SURVEYOR'S REAL PROPERTY REPORT
 PART 1 - PLAN SHOWING
BLOCK 12
REGISTERED PLAN 4M-1720
 CITY OF OTTAWA
 J.D. BARNES LIMITED
 © COPYRIGHT 2025

PROPOSED RESTAURANT BAKEHOUSE

Re: Building Application for 1837 MAPLE GROVE RD, Ottawa, ON
Application No: CON-2025-017412

The following are our responses to your comments of November 27, 2025 regarding the **Building Code** for the above project:

SITE PLAN
LOCATION PLANS

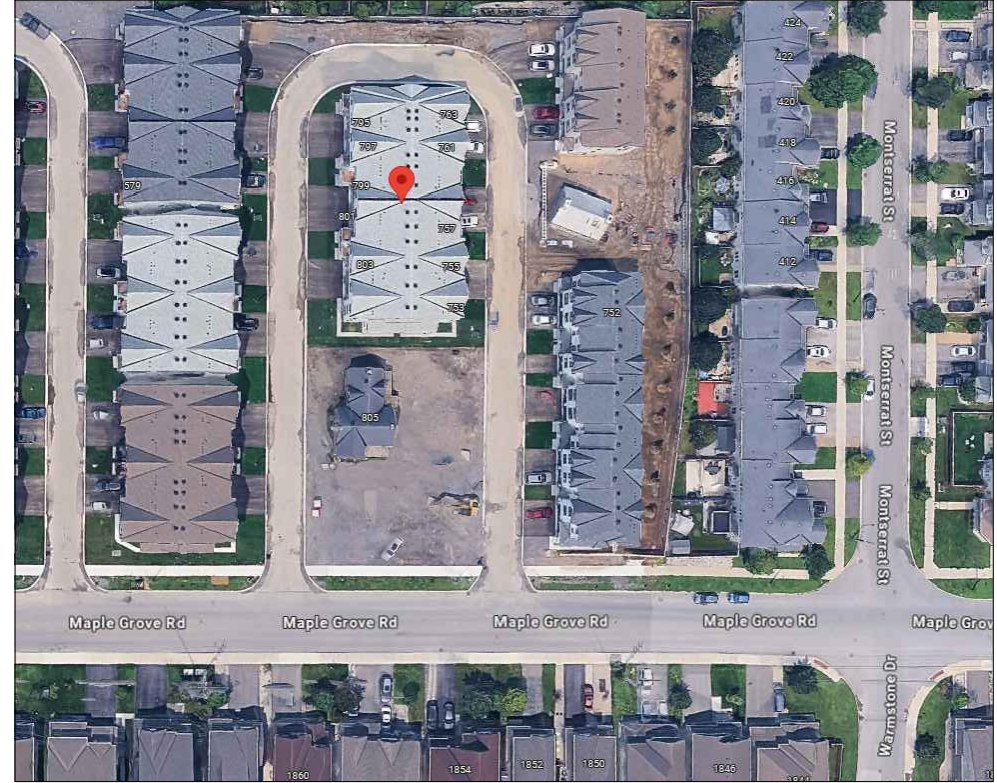
3 3) The fire access route, has now been shown on the Site Plan as per 3.2.5.5.(1), of the O.B.C..

3 3) A fire access route has been added on the site plan to the front entrance door. Aerial photos have also been added indicating the location of the adjoining streets.

01 SECTION 1
A-401 3/16" = 1'-0"

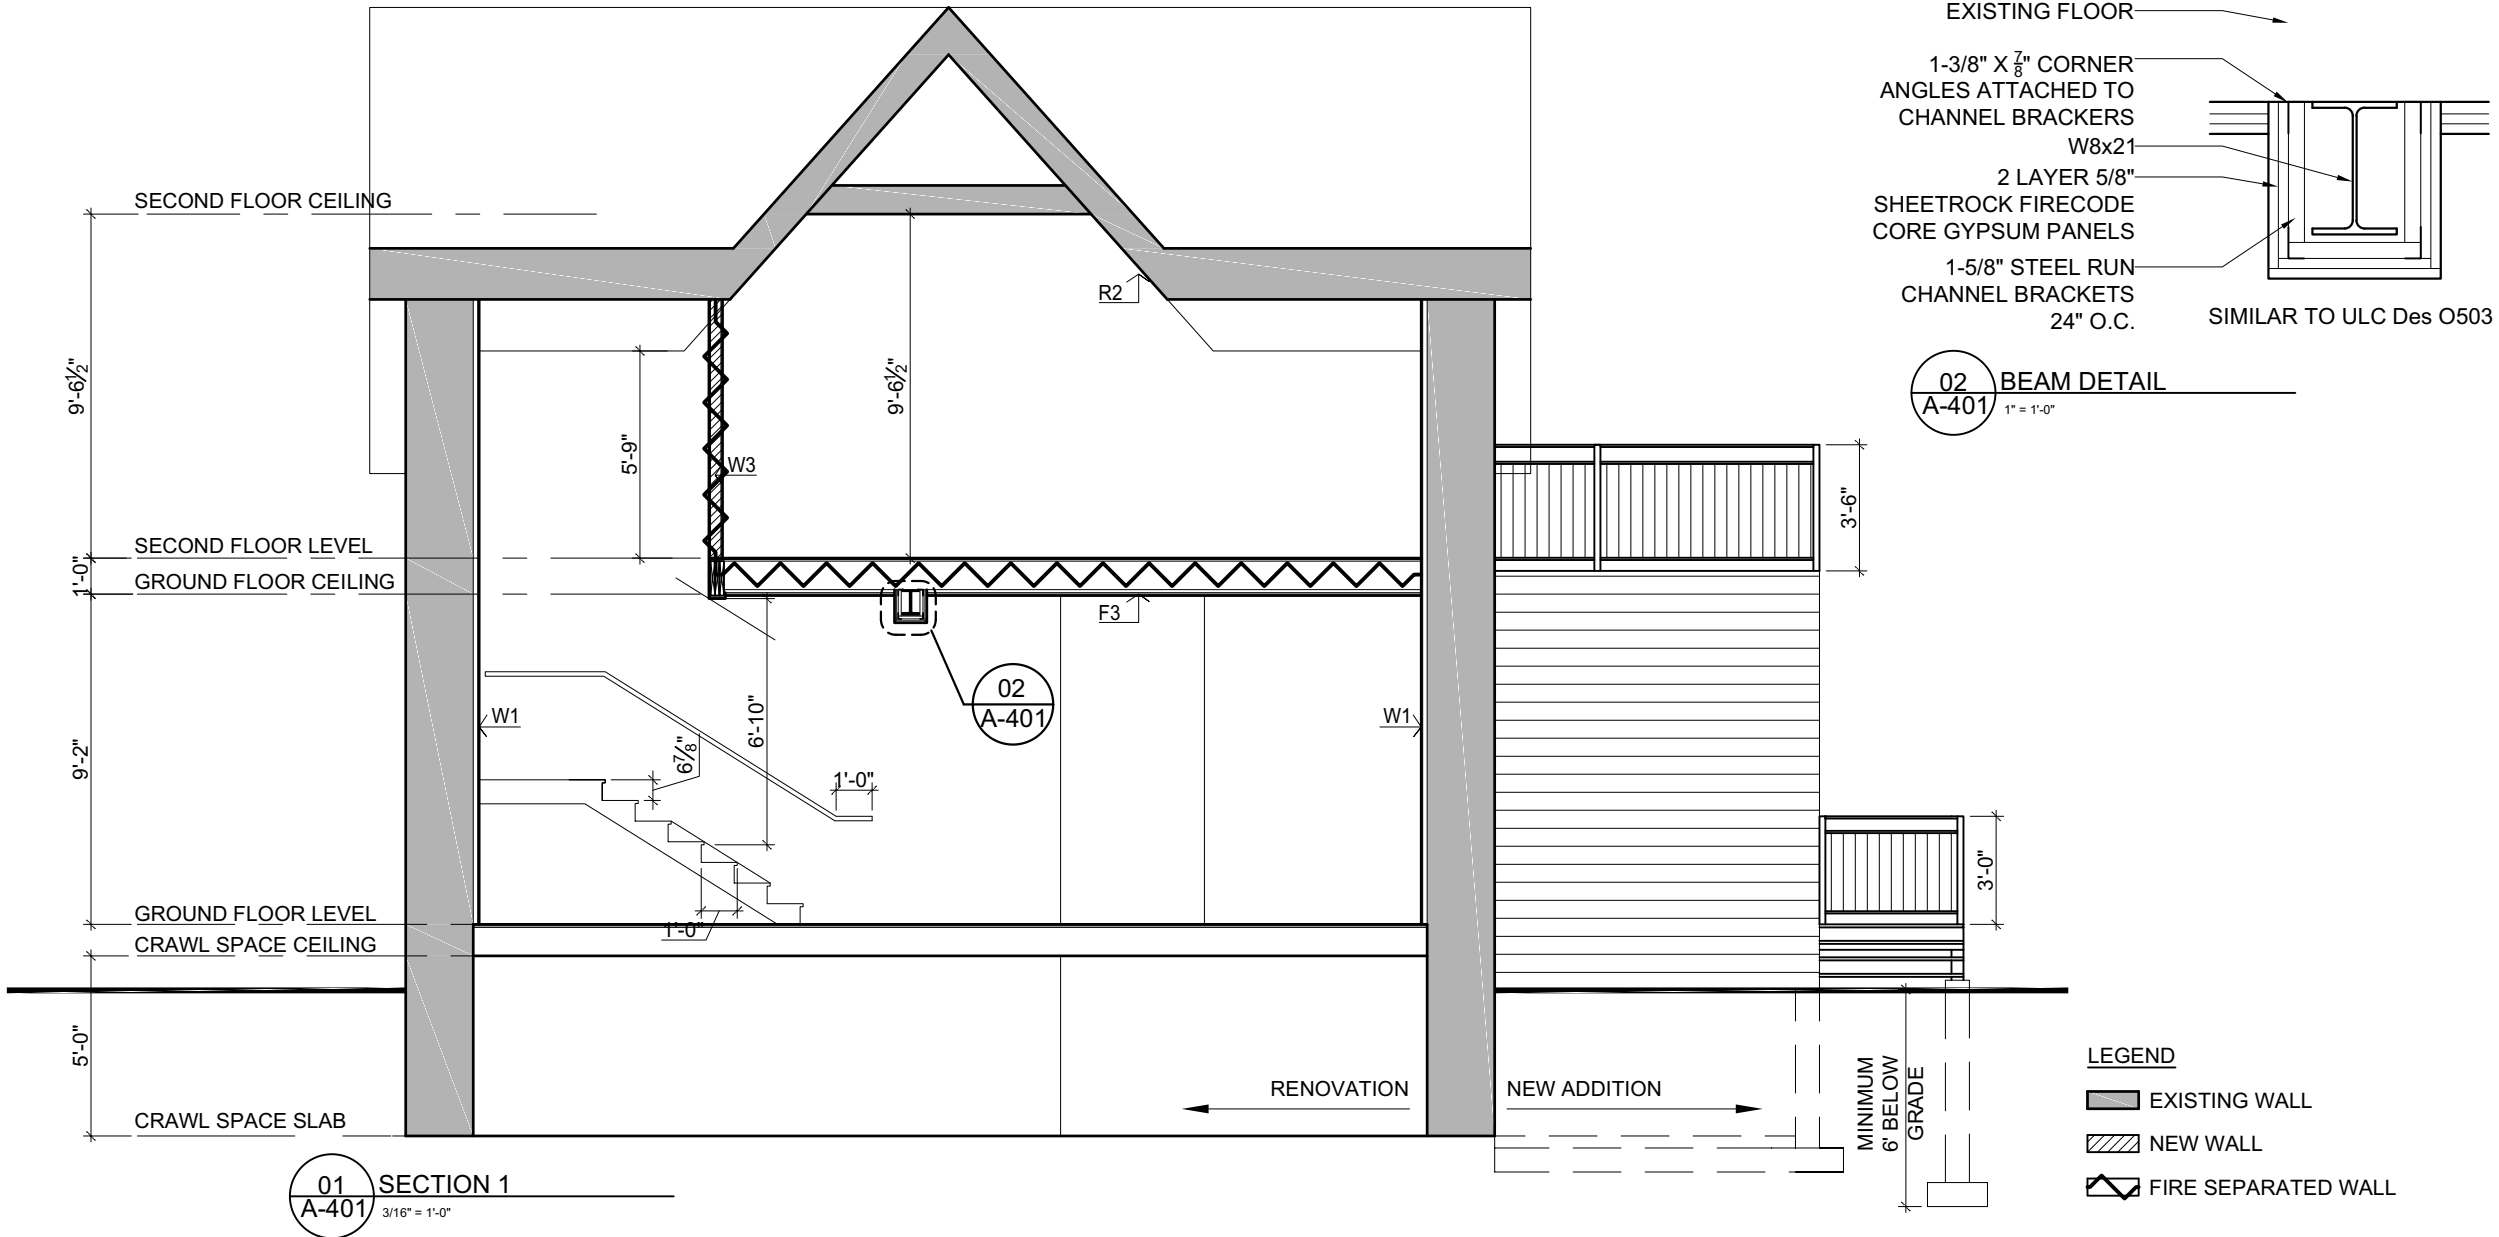
6 6) The 2nd floor construction is fire rated according to SB2, see drawing A-401. There will be 2 new layers of Type X gypsum board. There is a section detail 02/A-401 showing the assembly for the protection of the dropped beams.

BASEMENT PLAN

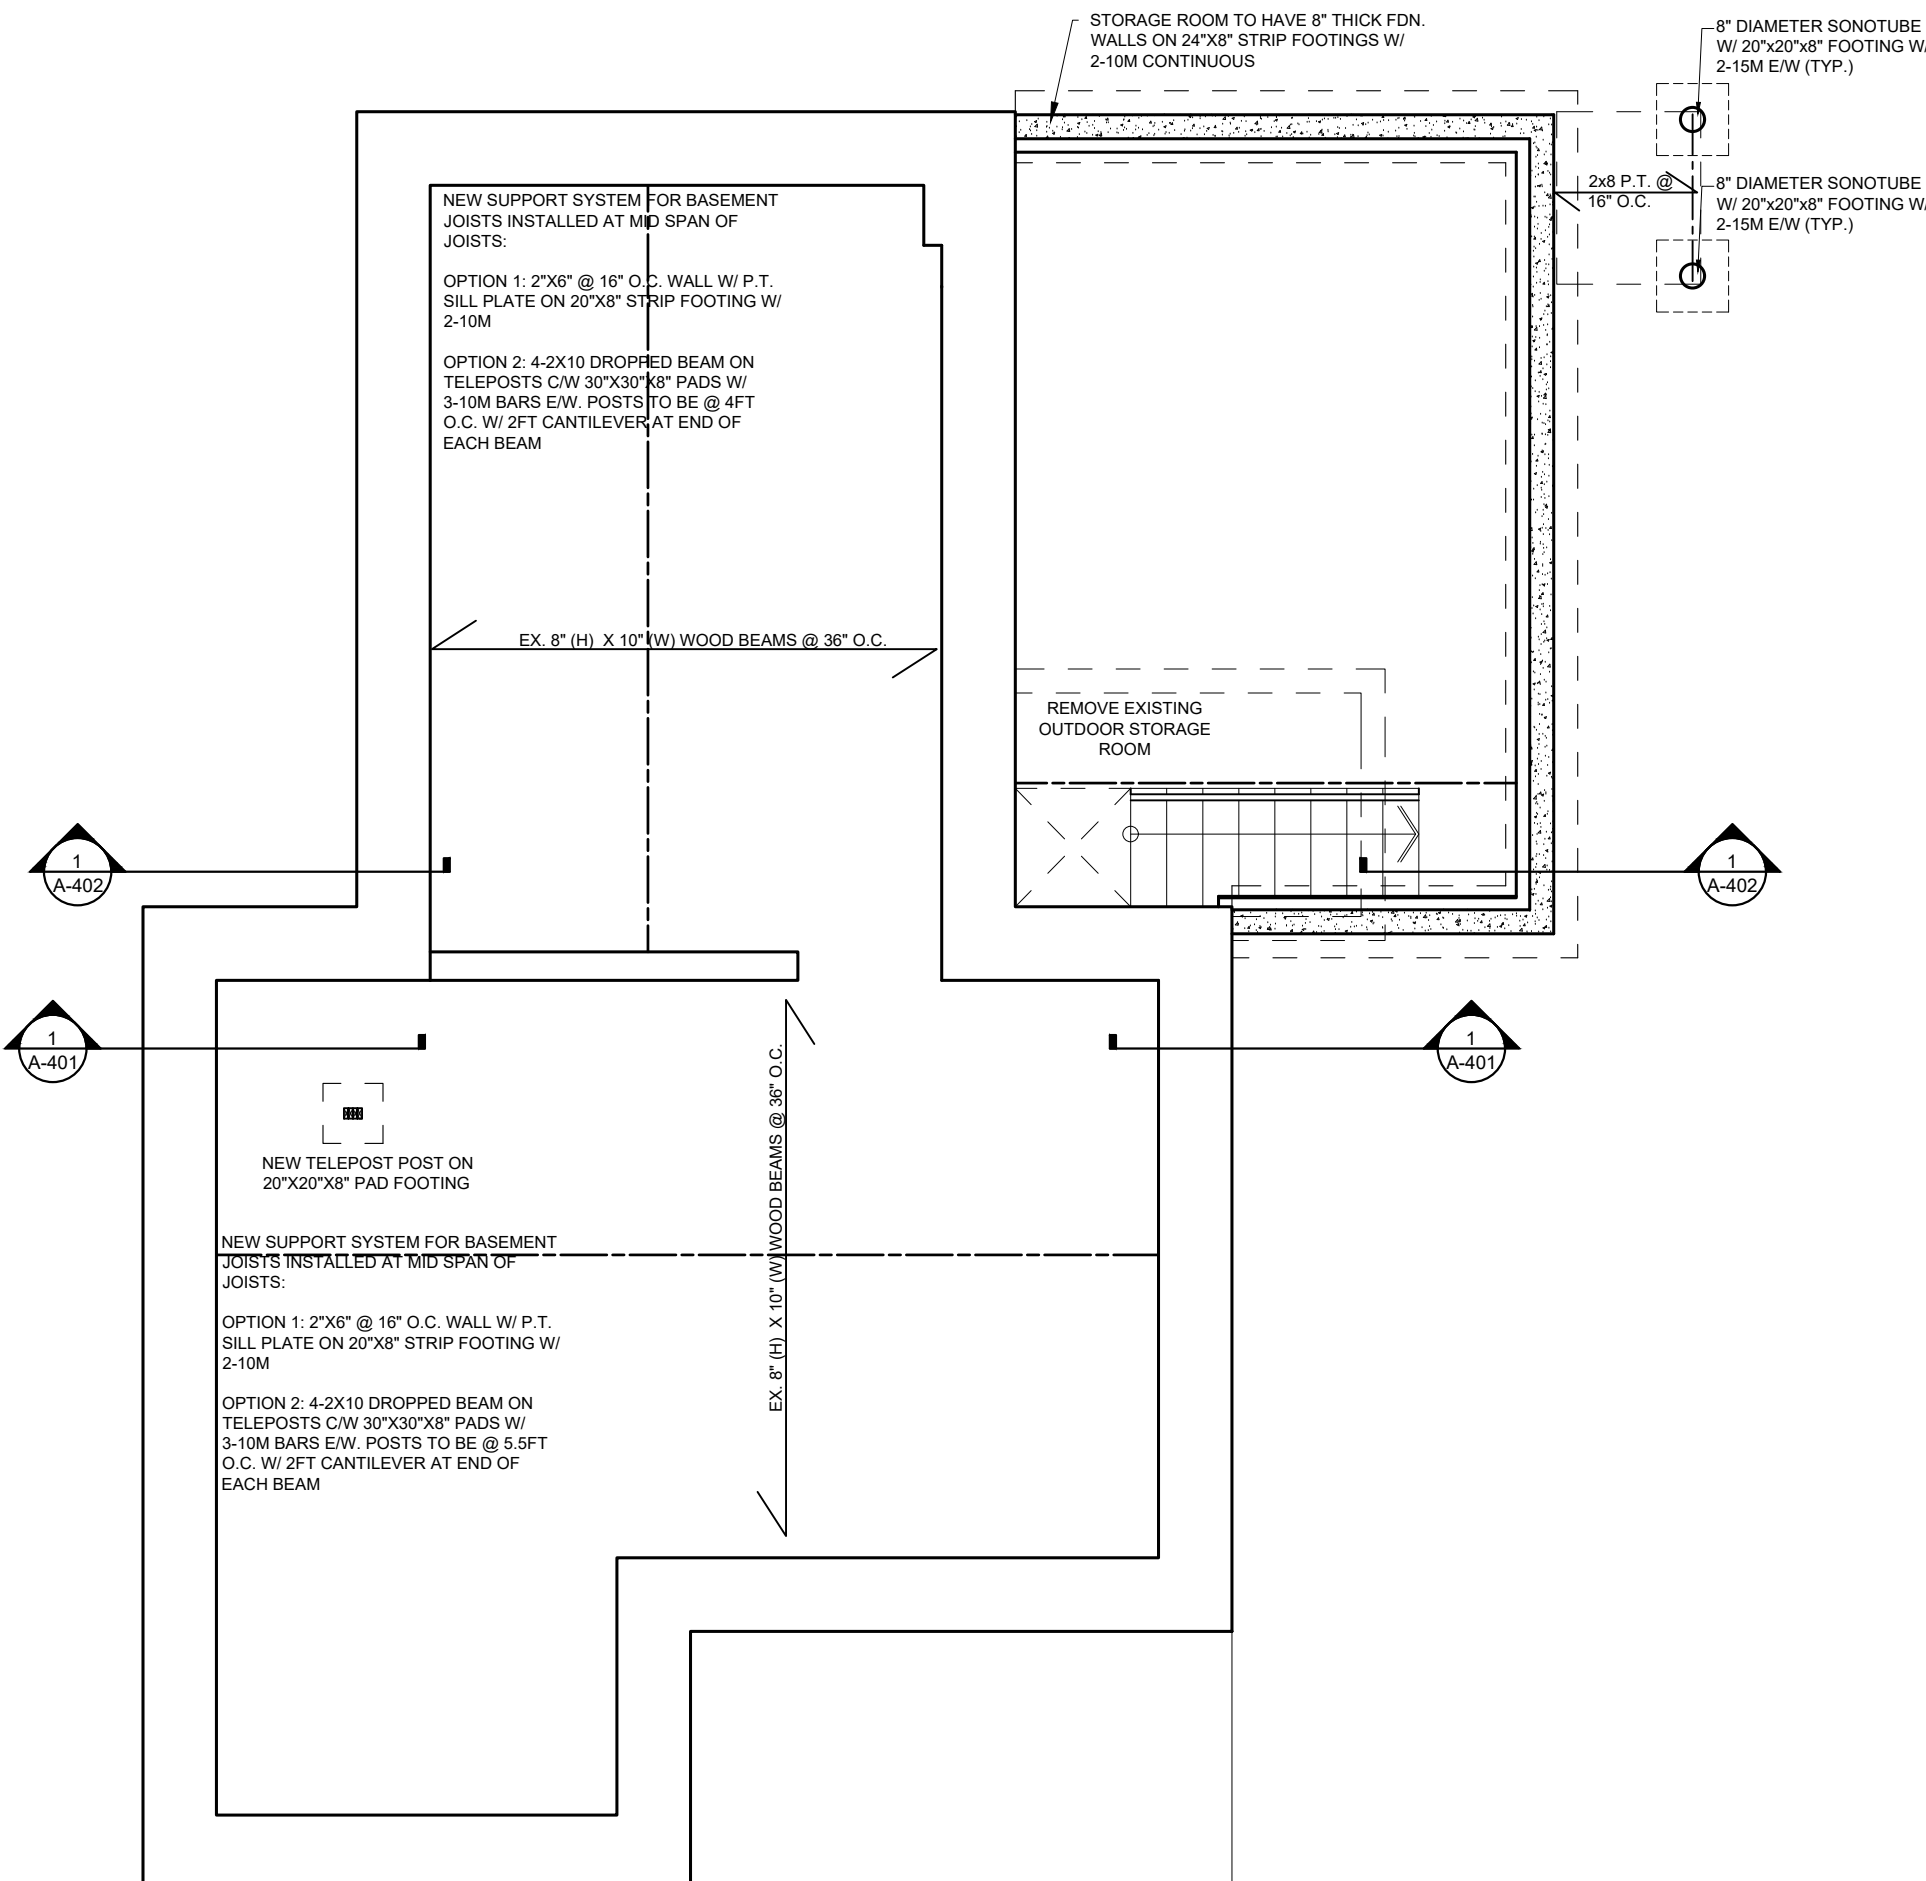
9 3) There is now a note on the Structural Basement Plan indicating that a report by a soils engineer is required before construction begins, see S1.
